**STAFF REPORT
KETCHUM PLANNING AND ZONING COMMISSION
REGULAR MEETING OF DECEMBER 9, 2025**

PROJECT: 140 & 180 N Leadville Ave ARCH Workforce Housing Project

APPLICATION TYPES: Design Review (Application File No. P25-033) & Lot Consolidation Preliminary Plat (Application File No. P25-039)

REQUEST: Final Design Review and Lot Consolidation Preliminary Plat applications for the ARCH workforce housing project at 140 & 180 N Leadville Avenue

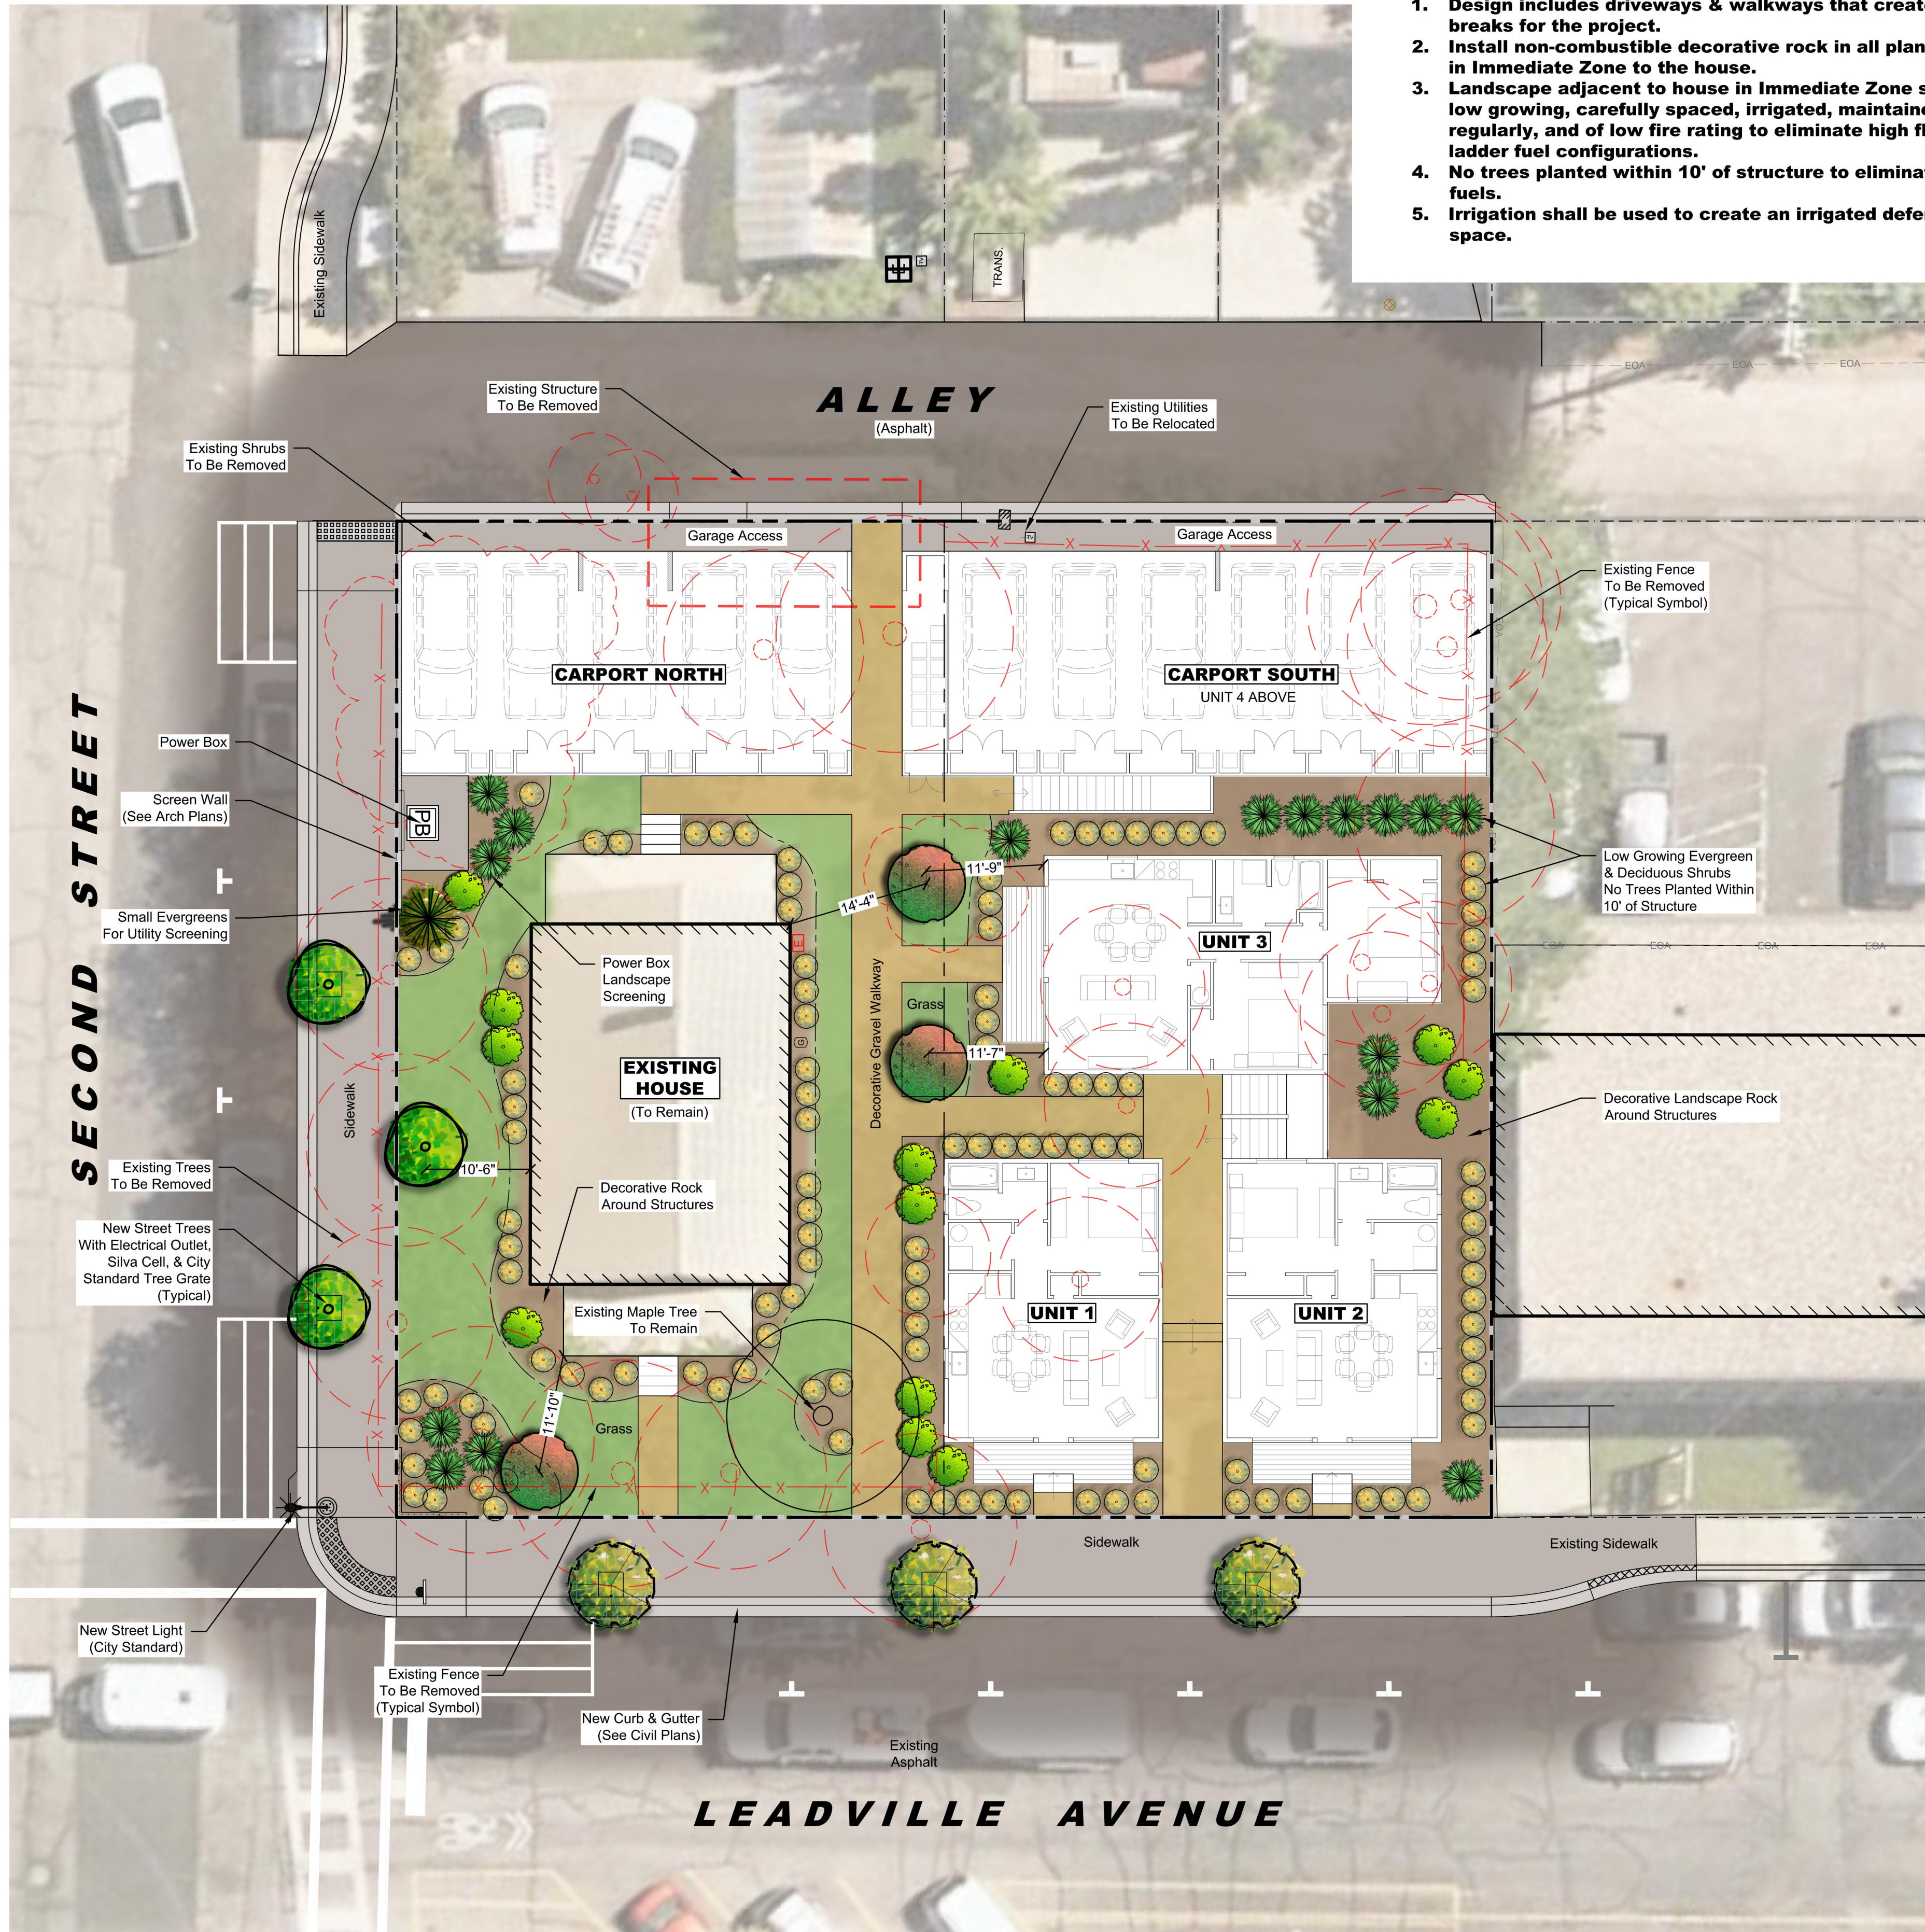
garbage disposal plan has been modified to address the Streets Department concerns about bins lingering in the alley. Sheet A.3 has been revised to include a garbage bin staging area in the south carport building and add bike storage for each unit. The revised landscape plan (sheet L1), exterior lighting specifications (sheet E.3), and garbage disposal plan (sheet A.3) are included as Attachment B to the staff report.

E.3

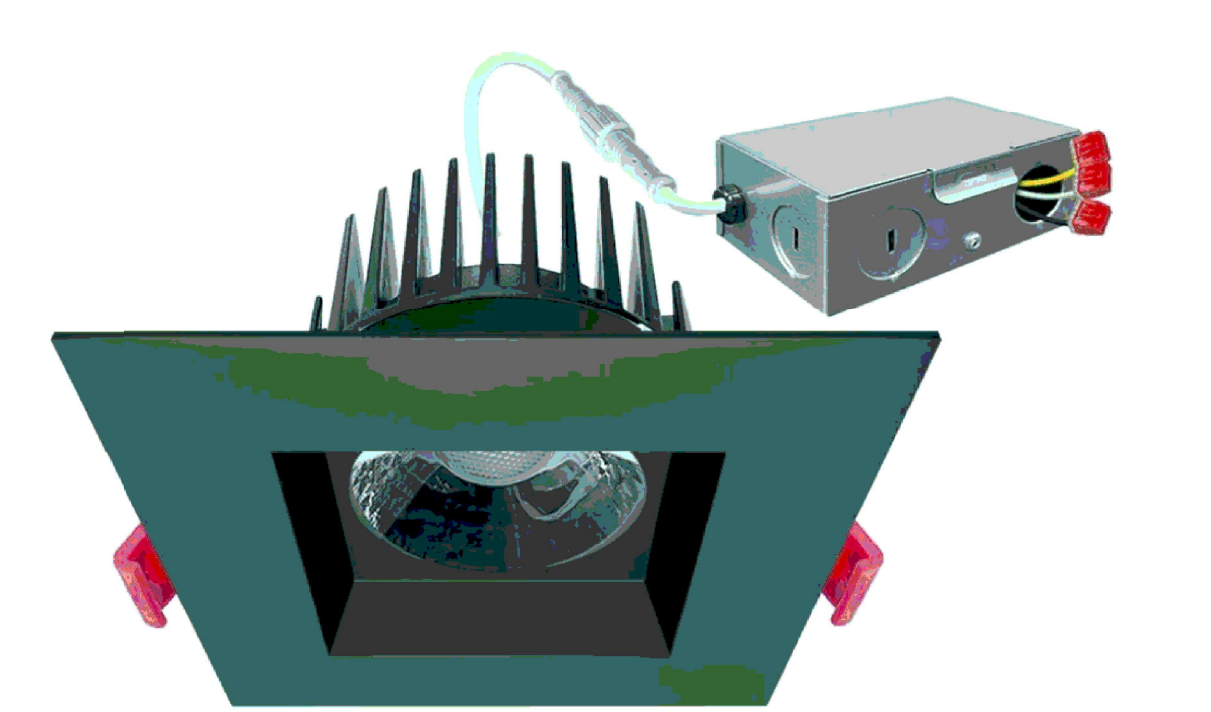
In addition to the color and landscaping changes, the applicant has addressed several other issues identified in the November 25 staff report. The applicant has updated the exterior lighting fixture specifications on sheet E.3 to note that the color temperature of the light source for each of the three fixtures is 2700K. As presented by staff and the applicant at the November 25 hearing, the

TMP SPEC 2700K
